Historic Landmarks Committee Community Development Center, 231 NE 5th Street May 15, 2018 3:00 PM

EXHIBIT 1 - STAFF REPORT

SUBJECT: HL 3-18 / DDR 2-18 – 608 NE 3rd Street

This is the consideration of a Certificate of Approval for exterior alterations to a historic landmark located at 608 NE 3rd Street. The subject property is listed on the McMinnville Historic Resources Inventory as a Distinctive resource, and is also classified as a secondary significant contributing property in the Downtown Historic District that is listed on the National Register of Historic Places.

Photos of the existing east façade, the exterior staircase, and a rendering of the proposed east façade are provided below:

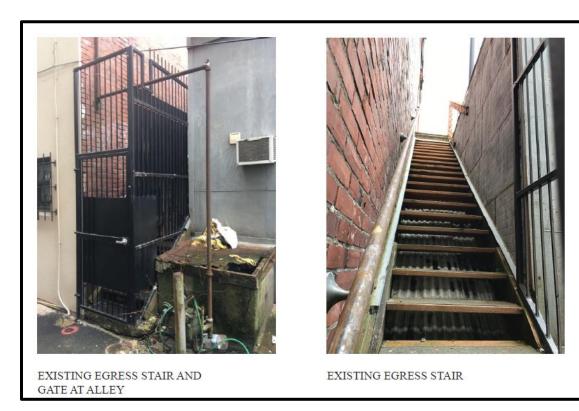
The proposal to remedy those issues is to remove the exterior staircase, close the three openings on the east façade of the building, construct a new interior staircase that will provide egress from the second story and the basement, and open a new doorway on the southeast corner (alley side) of the building. Brick from the new opening will be used to fill in the three existing openings on the east side, or to replace existing brick in other locations on the north and west facades that is too spalled to repair.

The closing of the three existing openings on the east facade, which include one doorway that opens to the exterior staircase that is proposed to be removed and two windows, is also being completed to provide for a 3-hour fire rated separation between the subject building and the adjacent building.

A comparison of the existing elevations and the proposed elevations, along with rendering of the proposed elevations, are provided below to show how the prominent masonry work and details will be retained:

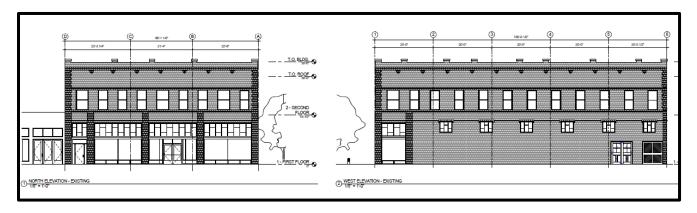
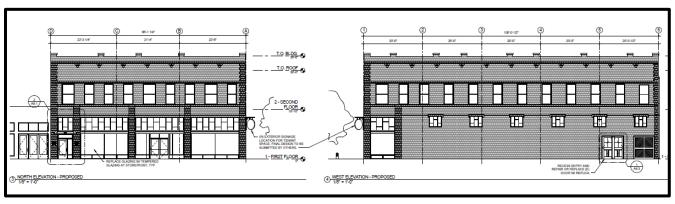
This criteria describes the need to avoid the replacement of intact or repairable historic materials or alteration of features, spaces and spatial relationships. The burden is on the applicant to provide that the historic materials cannot be repaired if they are interested in replacing them. The applicant is proposing to retain the original exterior masonry walls, stating that the existing brick will be cleaned, repaired, and repointed. However, the applicant is also proposing to replace the original storefront window glass and the upper story windows. The existing storefront and mullion system will be retained and cleaned, and new glass panes will be placed within the existing mullion system. A condition of approval has been included to require that the distinctive features of the storefront system described in the National Register of Historic Places nomination, including the original bronze fasteners that connect the plate glass and the wood framing system, be retained and repaired.

In addition, the applicant has stated the need to replace the second story windows on the premise that they cannot be repaired. The double-hung wood frame windows on the second story were identified in the historic district nomination as part of the architectural integrity of the building. The applicant needs to demonstrate that they are not reparable or seek to repair and retain them. Since the time of application, the applicant has removed one window in its entirety to further evaluate the window and determine whether repairs are possible, or whether they are so deteriorated that they need to be replaced with exact replicas using the same historic materials. A condition of approval has been included to require that the applicant provide detailed information on the findings of the evaluation and the existing conditions of the windows, and that the Planning Director have the ability to review this information and decide whether the windows can be replaced. If they are found to be too deteriorated to repair, the applicant is proposing to replace the windows on the second floor with exact replicated wooden windows, which will be crafted by a window specialist using an existing window as a template.

- 1. That the applicant provide detailed information on the findings of the evaluation of the existing windows and a more detailed summary of the existing conditions of the windows, and that the Planning Director have the ability to review this information and determine whether the windows are damage beyond repair. If found to be damaged beyond repair, the Planning Director shall have the ability to allow for the second story windows to be replaced with historically compatible and replicated windows, as described in the application narrative.

A rendering and elevation drawing showing the awning depth and design are provided below:

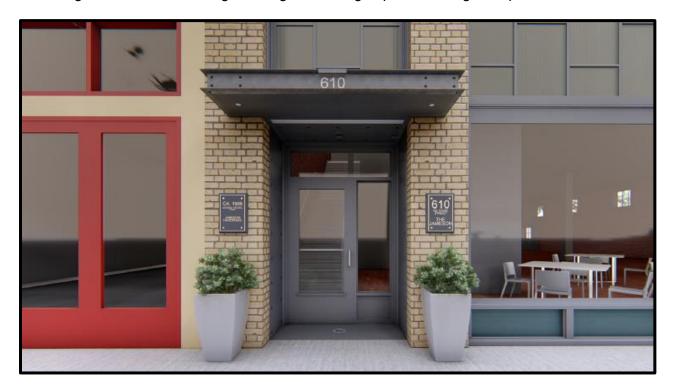
The canopy will project from the 5'-6" wide recess between the two flanking columns. In order to provide more protection at the entrance, the canopy, once over the sidewalk expands to 8'-0" wide by extending fifteen inches over the two, twenty six inch wide columns. The column can still be seen extending from the ground to the second story. Findings to support the design waiver and allow for the canopy to extend over a portion of the flanking columns are provided below.

The applicant has provided an argument that the demonstrable difficulty in meeting the code requirements for the steel awning are relative to the seismic upgrade. The Taylor-Dale building is an unreinforced masonry building and most of the steel added for the seismic upgrade will be added within the interior. The entrance to the second story will be an exception. Half inch steel plates are proposed to strengthen and contain the brick columns flanking the entrance. The steel plate was proposed to be visible on the exterior within the second story entry recess. However, as part of the Certificate of

Finding: The use of steel for the canopy allows for a durable and welcoming solution which can be mounted directly to the steel needed for the seismic upgrade. The proportions of the building and its defining elements are preserved. The design allows visibility of the building's architectural features, door, transom, clerestory, and pilasters. It respects the proportions of building and rectangular geometry of the street facades. The existing main architectural elements will still be dominant, unifying features of the façade.
